STAFF RECOMMENDATION

1508 Boscobel Street

Application: New construction-infill

Description of Project: The applicant proposes to demolish the existing non-historic house and to construct a new duplex.

Scale 3/16" = 1' FRONT
 ELEVATION

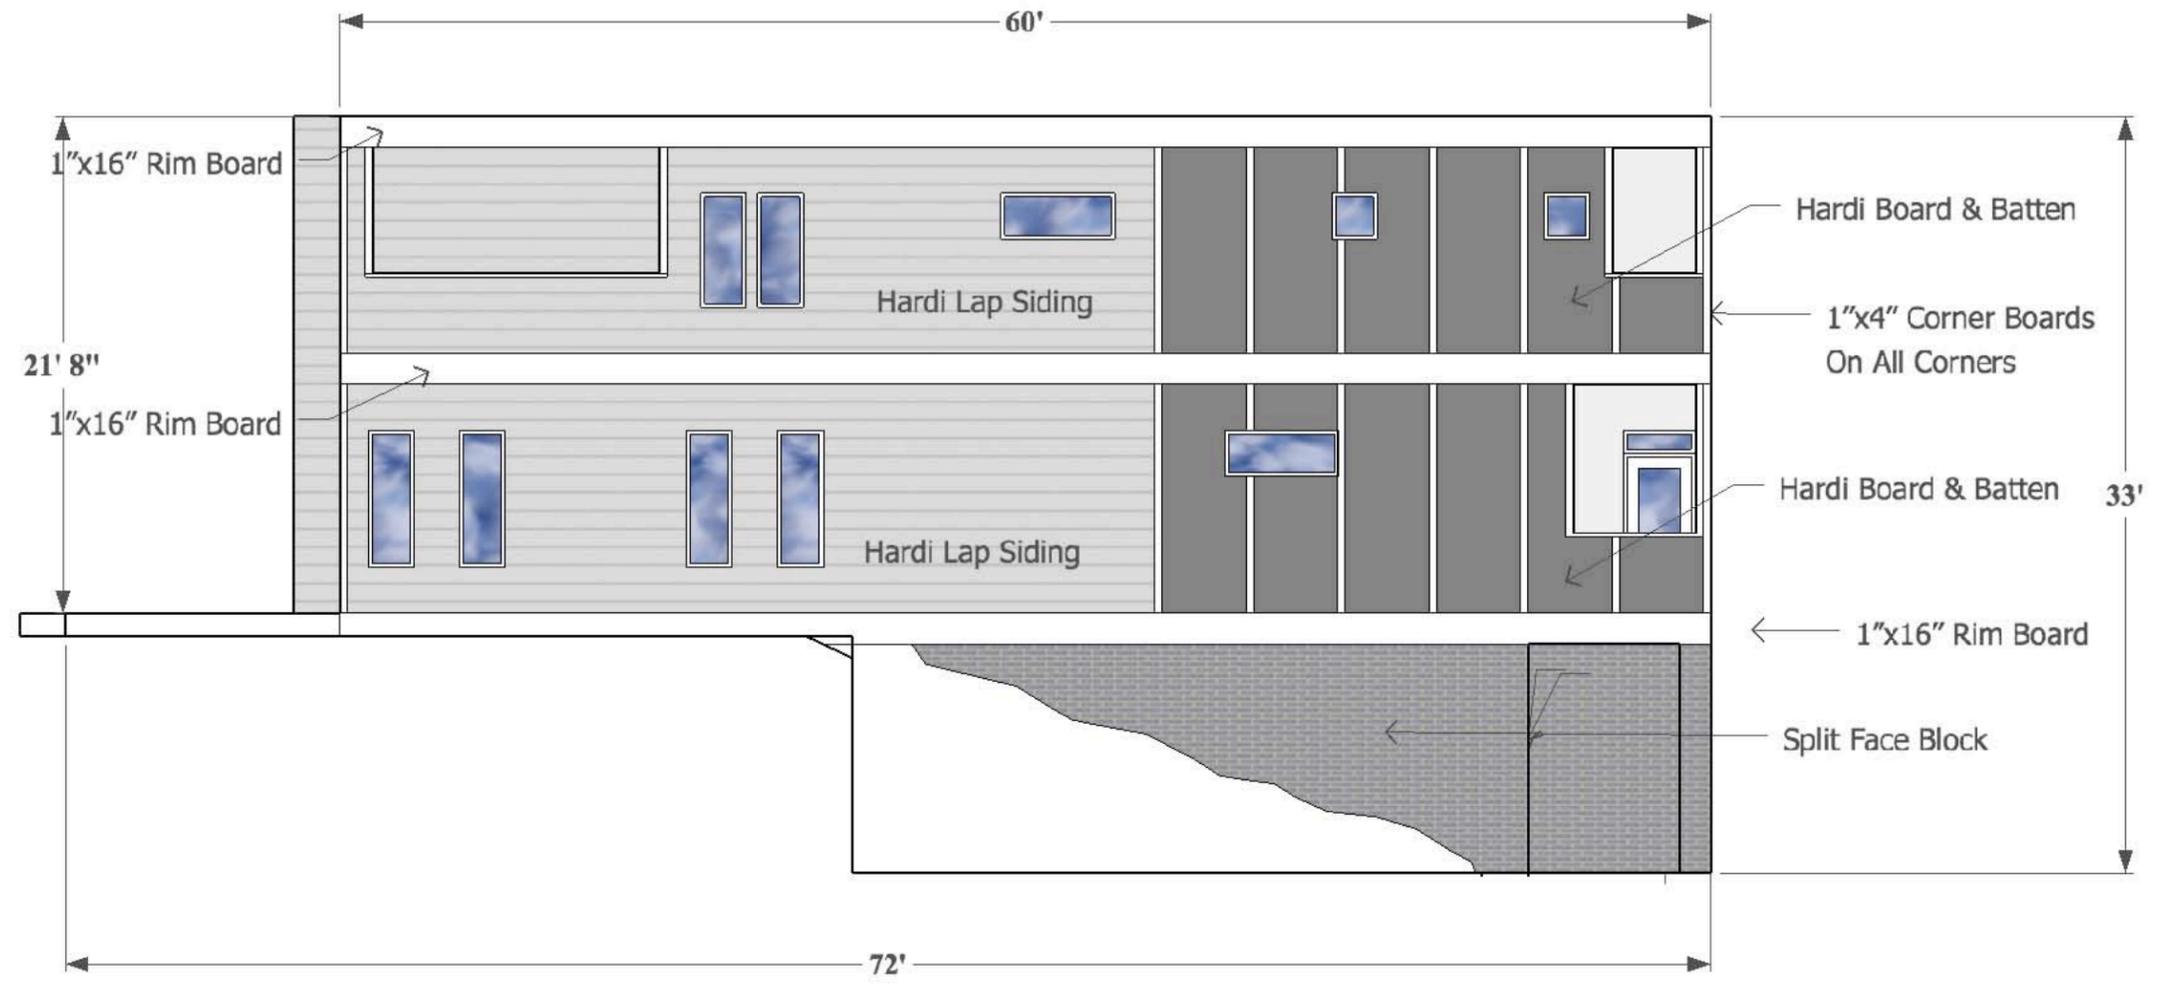
Orientation: The new building will be aligned toward the street, matching the orientation of the surrounding houses. The building does not have a typical front porch, but it does have primary entrances at the basement level and balconies on the front of the two main levels. Staff finds this configuration to be compatible with the context on this section of Boscobel Street because it does not have strong historic integrity. The site plan does not indicate any paved walkways. Typically, houses in the area have concrete walkways connecting the street or sidewalk to the front entrance. With the conditions that front walkways shall be added to connect the entrances to the street or sidewalk, and that there shall not be paved parking areas in front of the building, Staff finds that the project meets section II.B.1.f of the design guidelines.

Proportion and Rhythm of Openings: The windows on the front façade of the proposed addition are vertically oriented, as are the majority of windows on the sides. Overall, there are no large expanses of wall space without a window or door opening. While the proportion and rhythm of openings reflects a more modern influence than would be found on most historic houses, Staff finds that the infill will meet section II.B.1.g of the design guidelines because the 1400 through 1600 blocks of Boscobel Street do not have strong historic character.

- Window and door selections shall be approved by MHZC Staff prior to purchase and installation;
- Front walkways are added to connect the entrances to the street or sidewalk; and,
- HVAC be located on the rear façade, on a side façade beyond the midpoint of the house or on the roof, beyond the midpoint of the house.
